MEMORANDUM

From:	Built Heritage Officer		
Service	Green Infrastructure	App No:	252533
Address:	Reddam House, Bearwood Road, Sindlesham, RG41 5BG.		
Proposal:	Application for Listed Building consent for the proposed structural remedial works to stairwell.		
Heritage Asset:	Reddam House – grade II listed building Listed Buildings are classed as designated heritage assets under the NPPF (2024) and in the Council's Local Plan policies.		
Site Visit Made:	04/11/2025

Figure 1. View of underside of feature arch over ground floor landing.

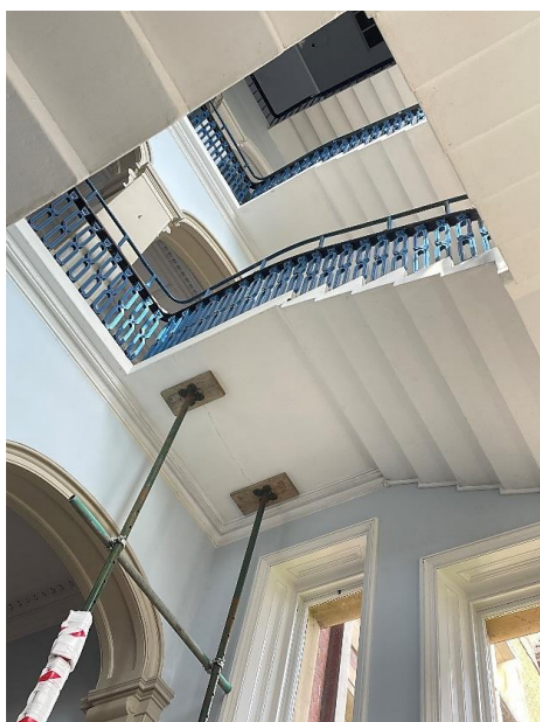
- Also not convinced the sections accurately show the height from the top of the archway opening (it is noted the arch moulding to the arch is not shown) and that of the ceiling/underside of the floor slab of the level above. The photograph attached shows a much smaller apparent gap.

- Whilst it is clear the height of the masonry walling above the decorative floor level archway landing opening to have installed the intended support brackets, albeit with one of the brackets seemingly would extend down to terminate close (best guestimate is less than 100mm) to the decorative arch moulding. In slab of the floor above resulting in a reduced area of masonry walling over the decorative moulded arch opening does suggest that it is questionable there is sufficient space to install at least one of the backing plates, which appear to be 500mm in length (best guestimate). As such there is concern spreader plates may affect the decorative moulding of the archways.

**EX. SECTION AT ARCH OPENING - UNDERSIDE
OF 1ST FLOOR REAR STAIRCASE (1:20)**

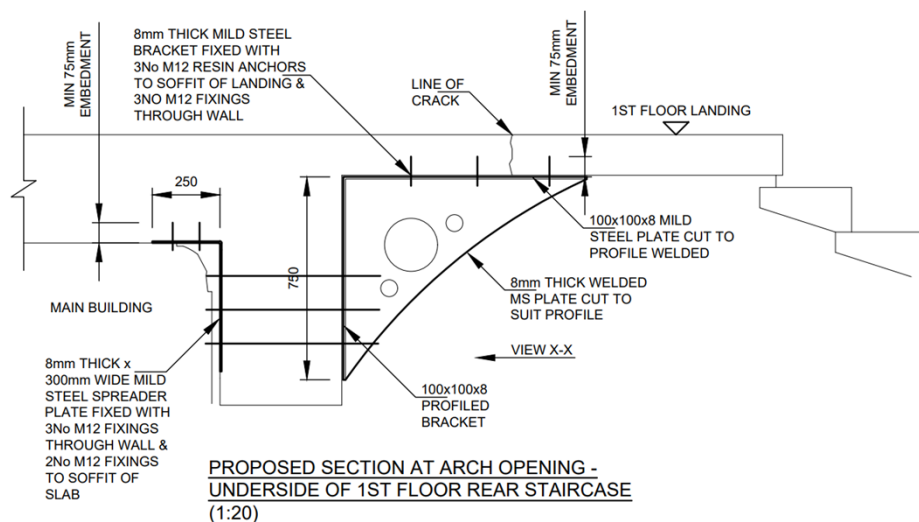
Firstly, there are two points it is felt need to be raised with respect to the submitted section drawings in light of that seen on site, namely:

- The sections do not accurately depict the profile of the cornice moulding, especially that of the crown moulding, which does not accord with the form and depth (projection out onto the ceiling).

From a heritage stance the concern here then is with the apparent intention remove part of these decorative cornice mouldings in order to both affix brackets and their back plates to the masonry walling, with the submitted proposed section drawings appears to indicate the intention to have removed both the cornice moulding and wall plaster where the brackets are to be situated. Whilst the proposed elevation does not make it clear as to the extent of the cornice and plasterwork would need to be removed. Furthermore, with respect to proposed elevation plan it is not clear given the 'L' shaped profile of the brackets as to whether they are to be a mirrored pair or not. And whether, given the intention to cut back the plasterwork to the face of the masonry wall to be able mount the brackets as to whether the plaster would be re-instated over the back vertical portion of the brackets or not.

Notwithstanding the details submitted, prior to commencement of any works to remove plasterwork and cornice moulding in order to have installed the gallows brackets and spreader plates, details to confirm the position of the gallows brackets and spreader plates have been submitted to and approved in writing by the local planning authority. The details shall confirm installation of the brackets and spreader plates on the masonry walling over the arched opening to the floor level can be carried out without affecting the decorative moulding of the arched opening. Works to install the gallows brackets and spreader plates shall then be undertaken in accordance with the details as approved.

Notwithstanding the details submitted, no works to make repairs to the historic decorative cornice mouldings and the plaster to the walling until details setting out the methodology for the re-instatement of the cornice mouldings and wall plaster have been submitted to and approved in writing by the local planning authority. The reinstatement of the cornice mouldings and wall plaster shall then be undertaken in accordance with those details so approved.

PROPOSED ELEVATION ON ARCHED
OPENING AT GROUND FLOOR LANDING
TO REAR STAIRWELL (1:50)

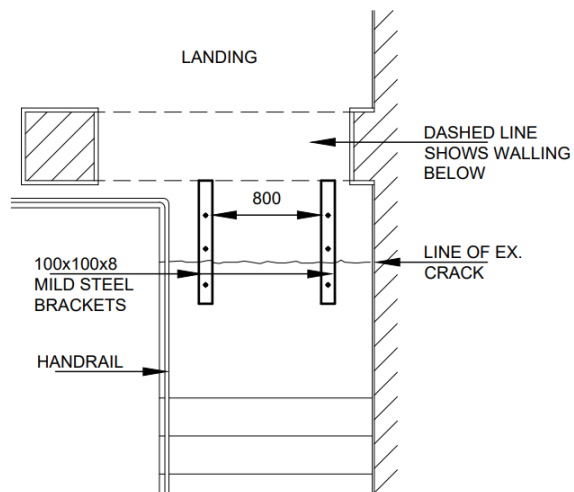
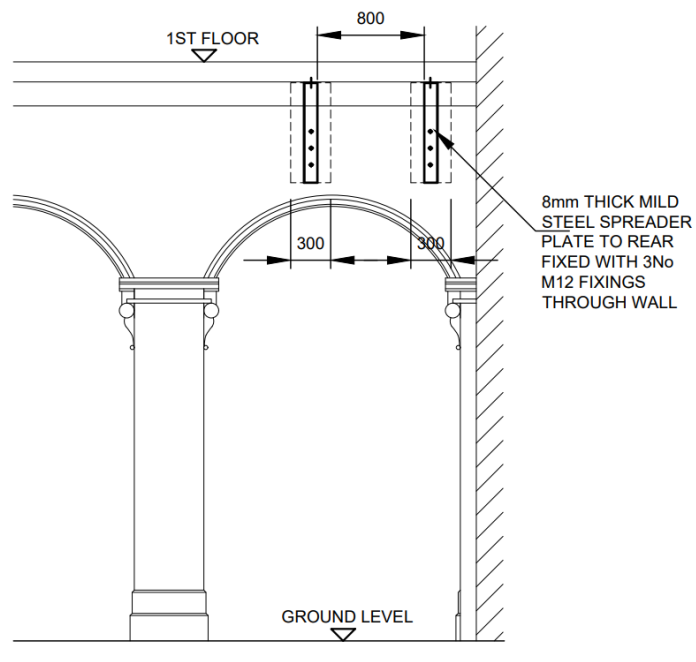
- The approach proposed will result in harm to historic original decorative moulding, as part of it will need to be removed along with the plaster to the walling/ceiling.
- The discordant visual effect of the positioning of the brackets being equally spaced on the underside cantilevered landing but in terms of the site the decorative arched opening off each the corresponding flight of stairs below would appear visually jarring in being offset/unbalanced to the architectural feature as viewed looking both up the stairwell of the back staircase, and

from on the stairs when looking directly to the arch opening floor level opening.

Notwithstanding the details submitted, prior to commencement of the works hereby consented for the installation of structural gallows brackets to support the back stairs, details for the design and finish of the gallows brackets shall be submitted to and approved in writing by the local planning authority. The installation of the gallows brackets shall then be undertaken in accords with the details as approved.
